Robinson Pool
Suggested Improvement
5-2-'45

Diagramatic Sketch
no scale used

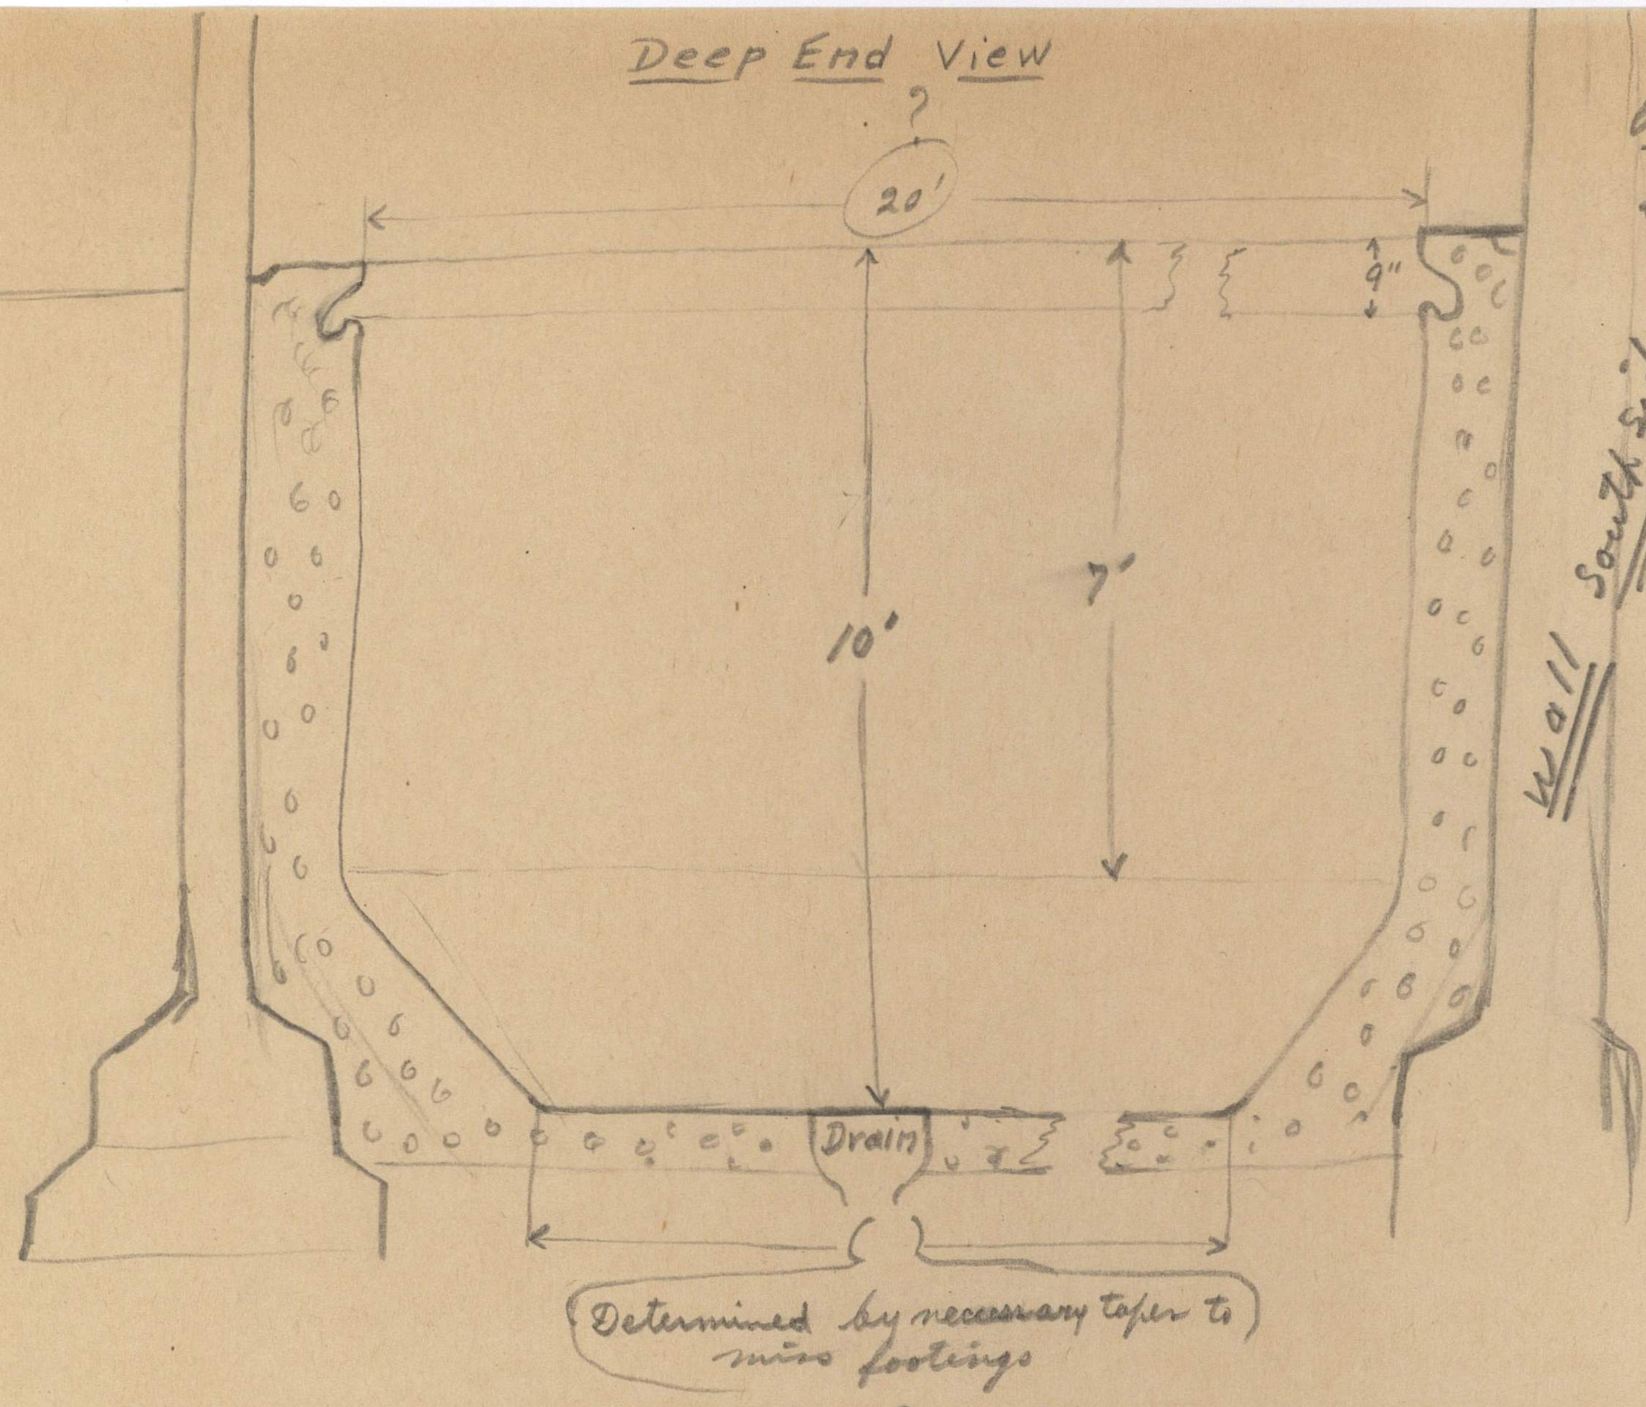
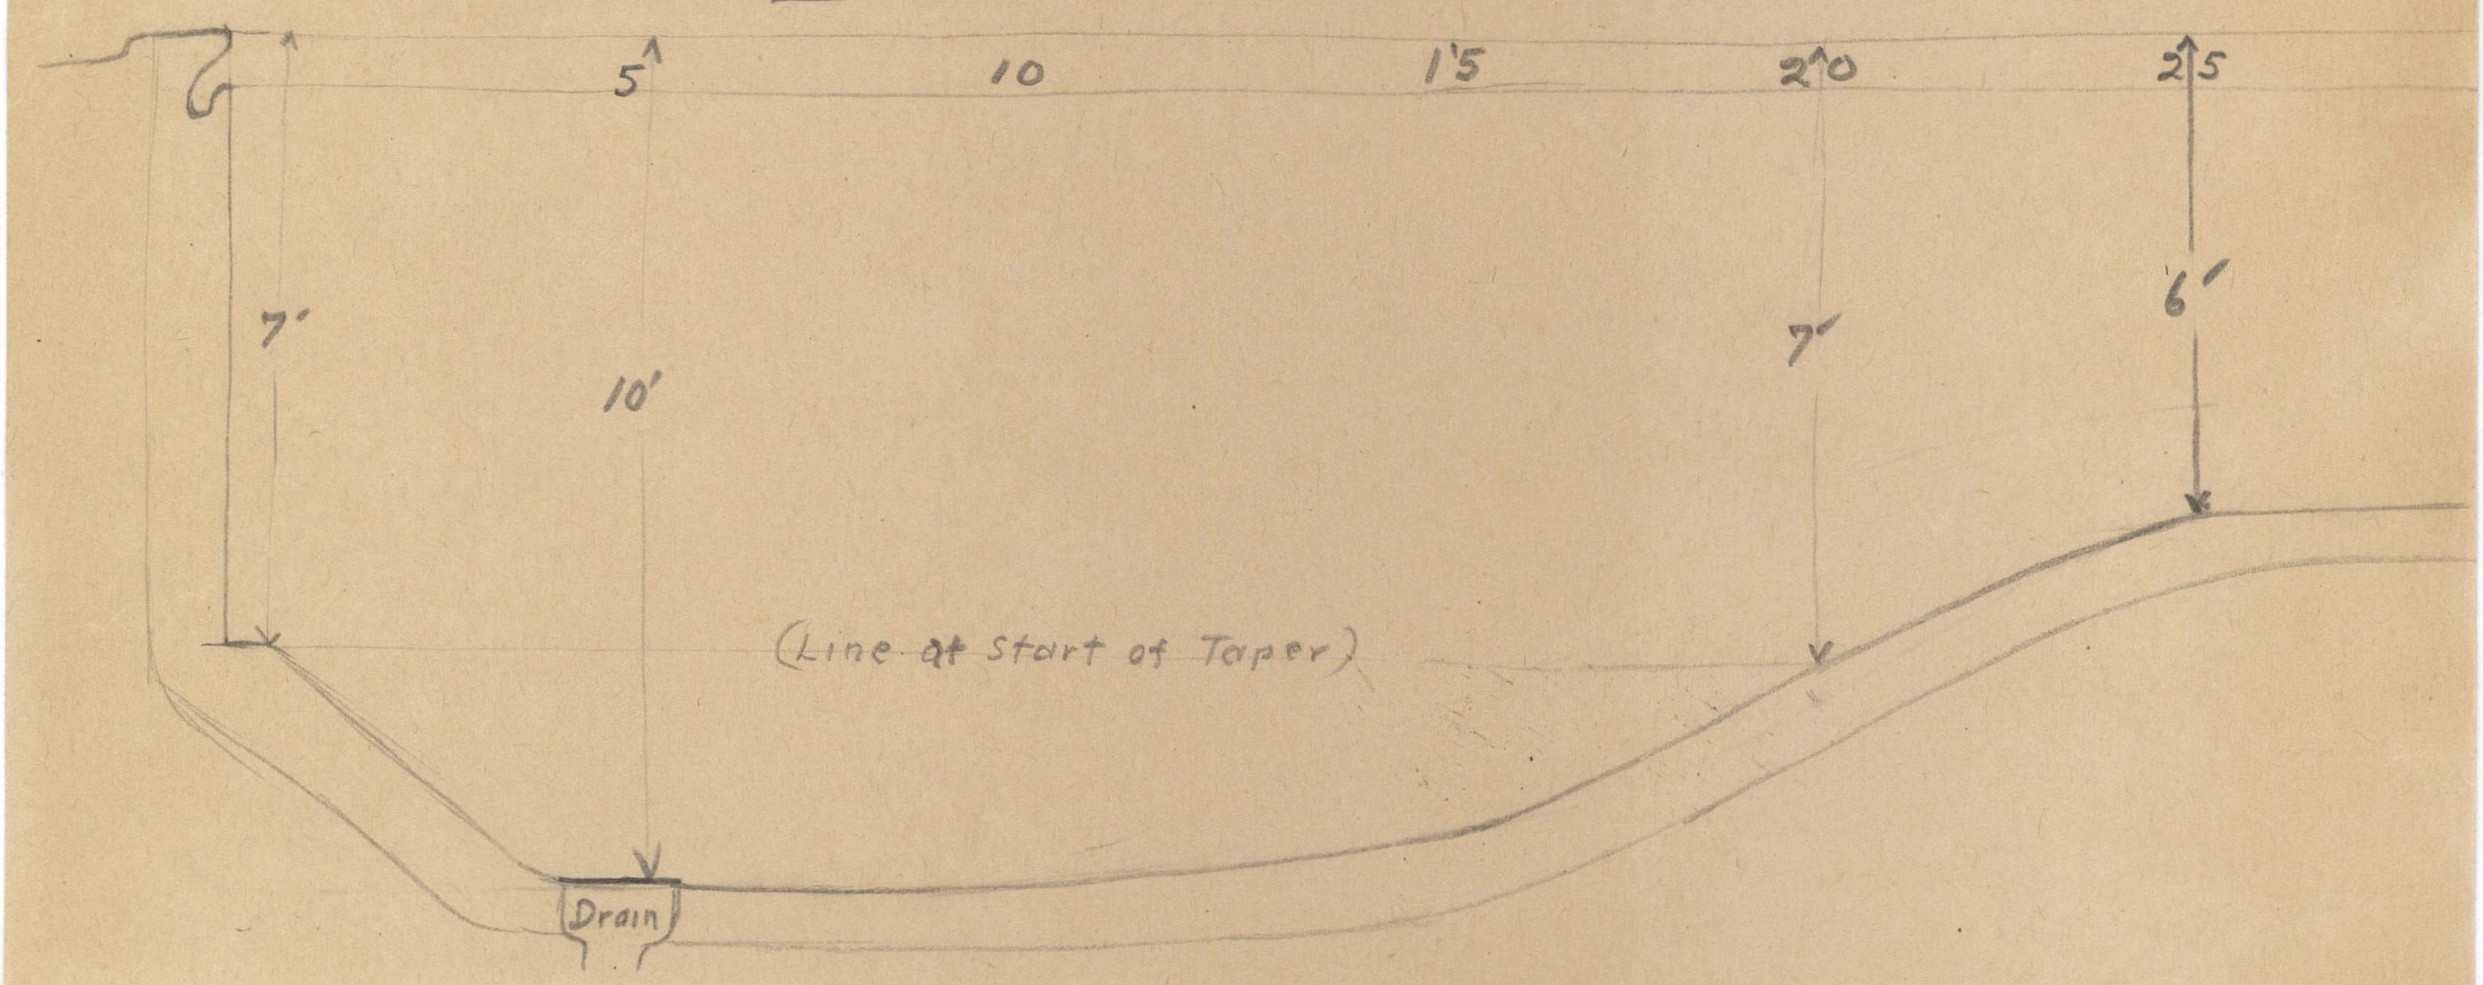
It seems that to taper the pool from about a seven foot depth to floor depth of ten feet would be advisable in order to get necessary depth for diving safety.

The degree of taper to be that necessary to miss the footing structure, thus maintaining as much all-over depth as possible.
